AREVA Enrichment Services LLC
Eagle Rock Enrichment Facility
NRC Docket No: 70-7015

Subject: Supplement to Eagle Rock Enrichment Facility License Application - Groundwater Analytical Data – Winter and Spring 2009, Ecology Field Study Report - Winter and Spring 2009, and Combined Geotechnical Report, Revision 6

Markup pages for the EREF Environmental Report

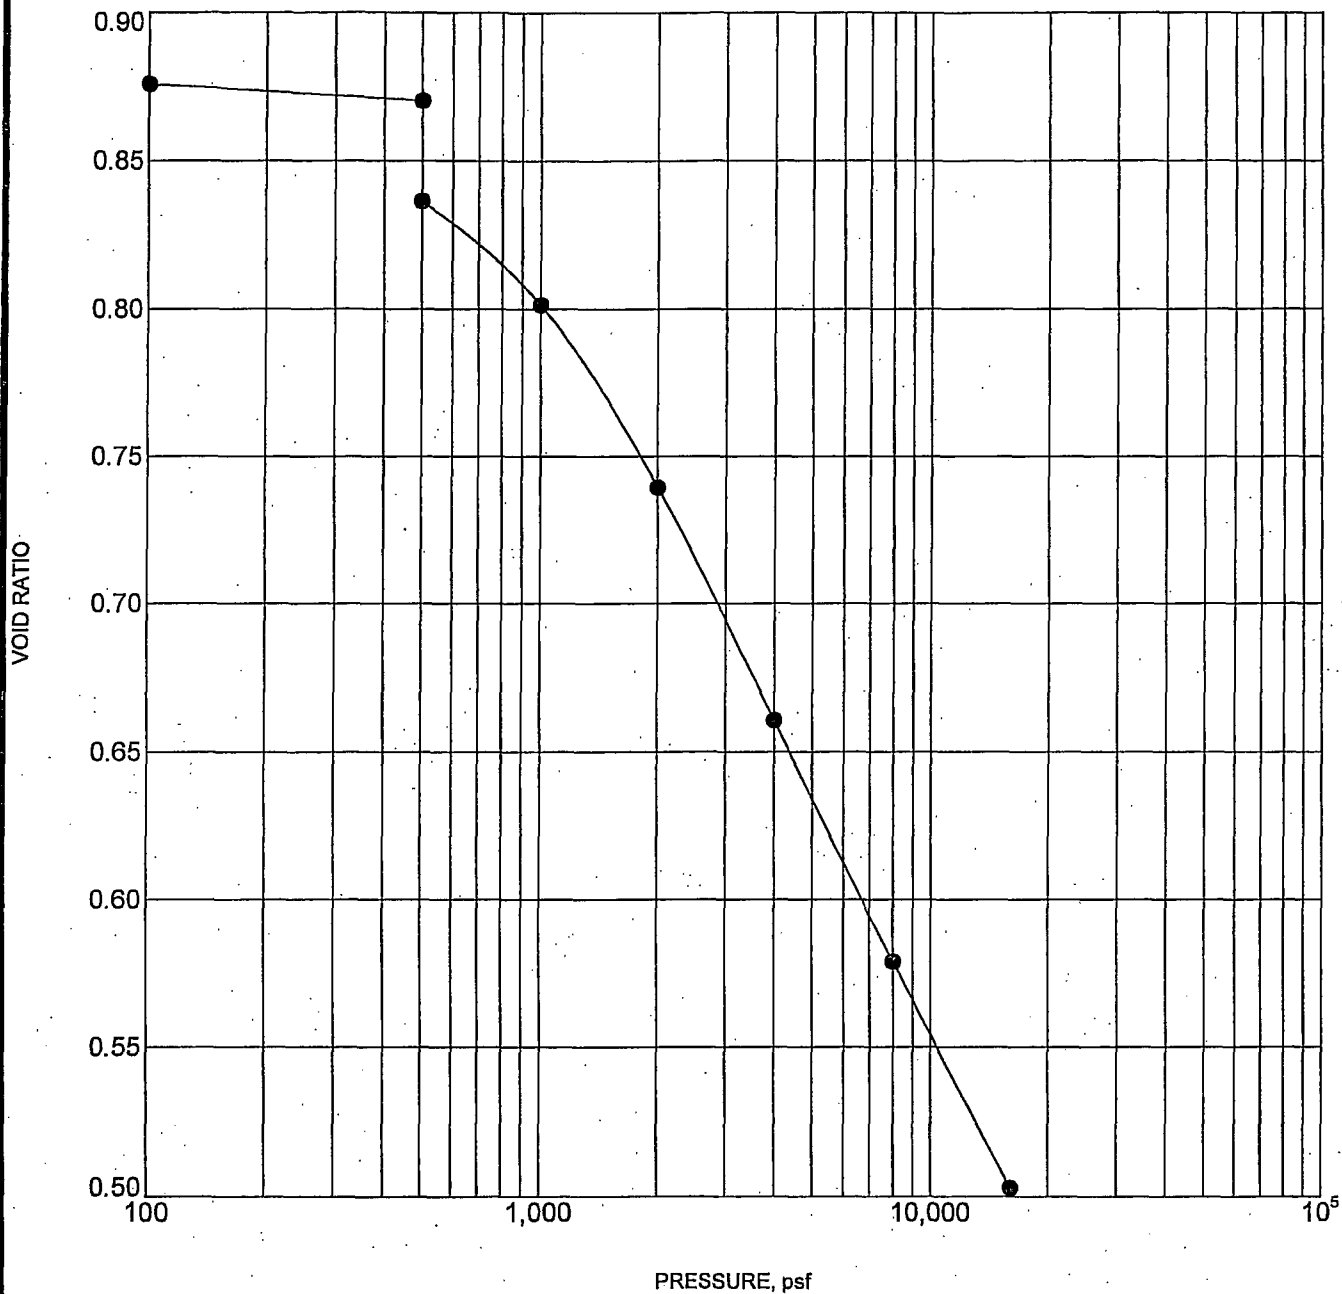
Insert BH12 10.5 FT CONSOLIDATION TEST after this page in Section 8.1 of ER Appendix E
(see attached BH12 10.5 FT CONSOLIDATION TEST from Geotech Report, Rev 6))
